Our Ref: 2022/762784

**SSD-26876801 - The New Forest High School (New educational establishment)**

Director Planning & Place Division  
**Referral Attachments**

Figure 2-5 Cycling catchment to the proposed site

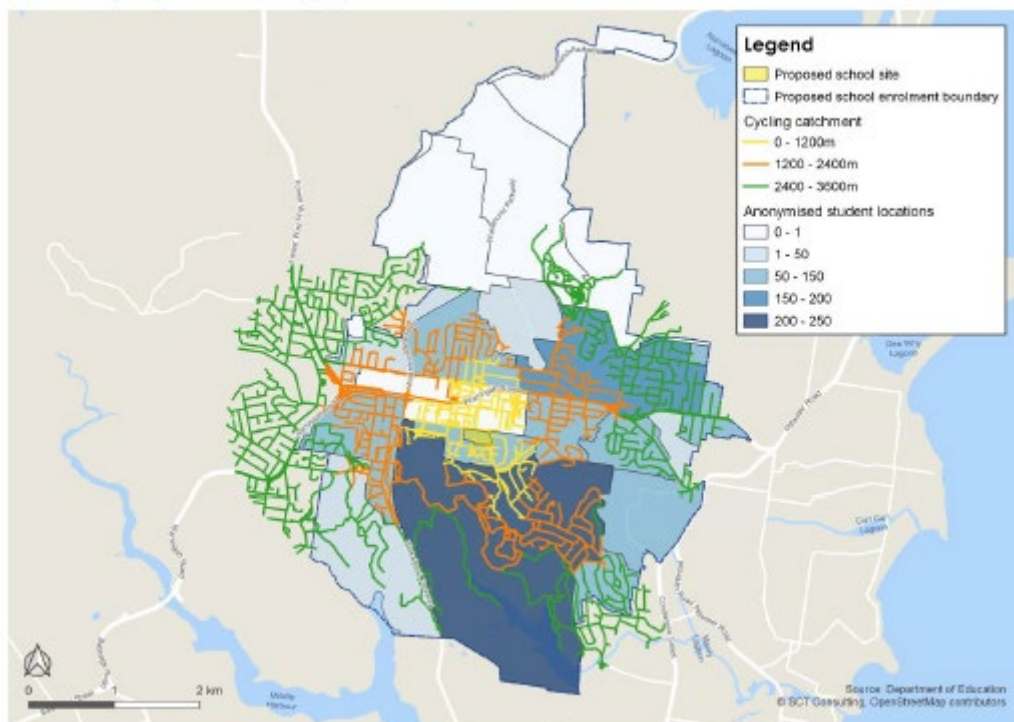
Figure 1 - The cycling catchment to the proposed school. This information should be used as the basis for a concept public domain plan that illustrates where cycle lane and associated infrastructure will be located and designed to create safe, convenient, and attractive routes to school for children and encourage sustainable transport modes (taken from SCT Consulting Transport Access Impact Assessment 2 Nov 2022).

Figure 2-3 Walking catchment for the proposed site

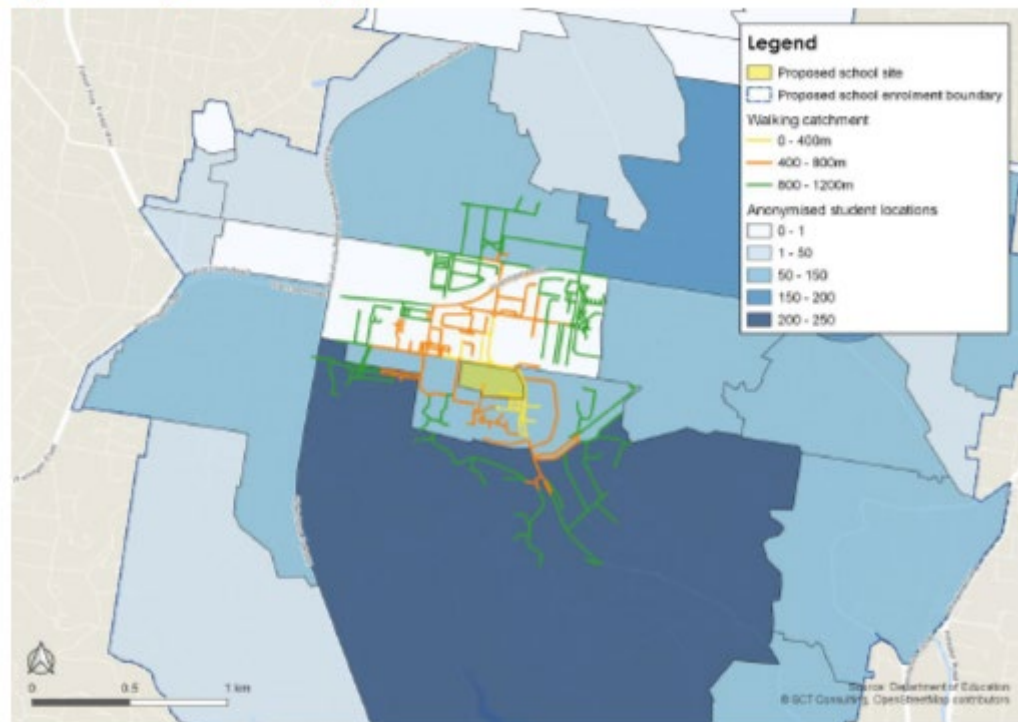
Figure 2 - The walking catchment to the proposed new school. This information should be used as the basis for a concept public domain plan that illustrates where footpaths and associated infrastructure will be located and designed to create safe, convenient, and attractive routes to school for children and encourage sustainable transport modes (taken from SCT Consulting Transport Access Impact Assessment 2 Nov 2022).

Figure 3 - Proposed accessible parking bay is obstructing the existing dedicated cycle lane.

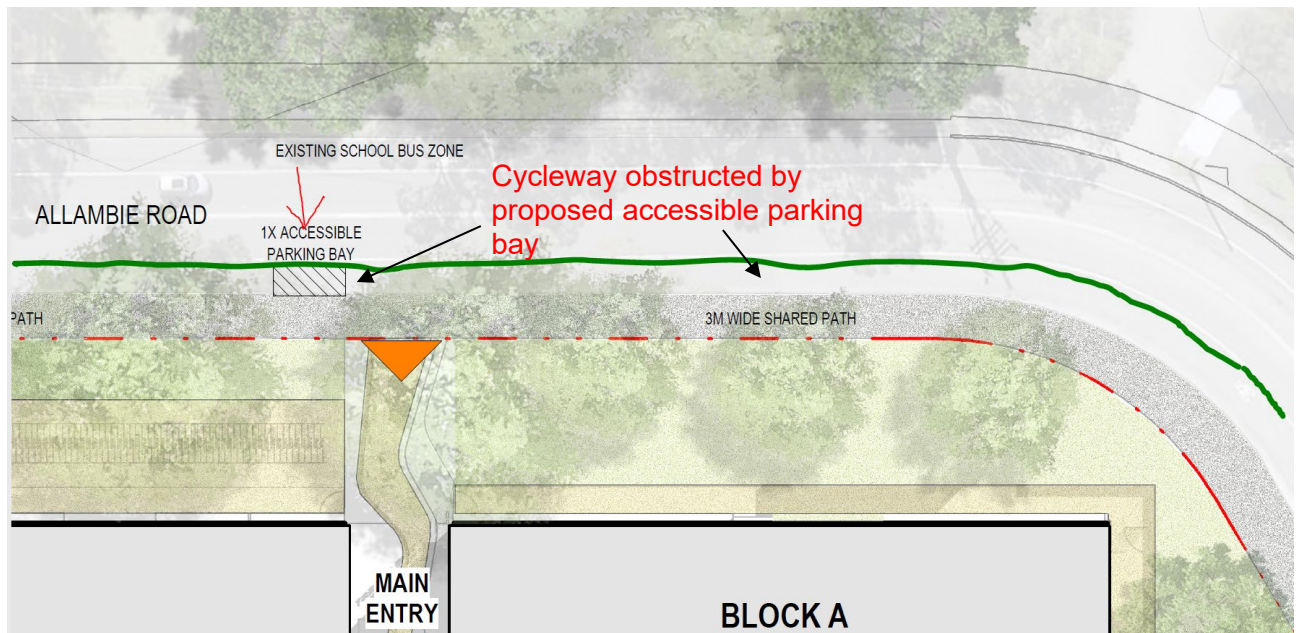
Figure 4 - Current Allambie Road public domain. Note the shared path with a dedicated (but not separated) cycleway on either side of the road carriageways. The proposal doesn't integrate with nor seeks to upgrade the public domain to provide for the new school.

Please provide the following: A public domain concept plan that shows where and how the applicant will provide safe cycle and footpath routes along the travel routes of students from the catchment areas to the school. Also, illustrate a coordinated public domain proposal for the interface between the school and the existing public domain showing upgrades for safe, convenient, sustainable movement. Illustrate the location of bus shelters for shade and protection from the rain and how they can work with dedicated cycleways, shared paths, vehicular traffic, accessible parking bays etc., and that enough clear width of travel is maintained along the routes of cycleways and shared paths. A coordinated detailed public domain concept plan that shows the applicant can accommodate proposals for the safe travel routes of children from the catchment areas to the school within the road reservation should be provided.
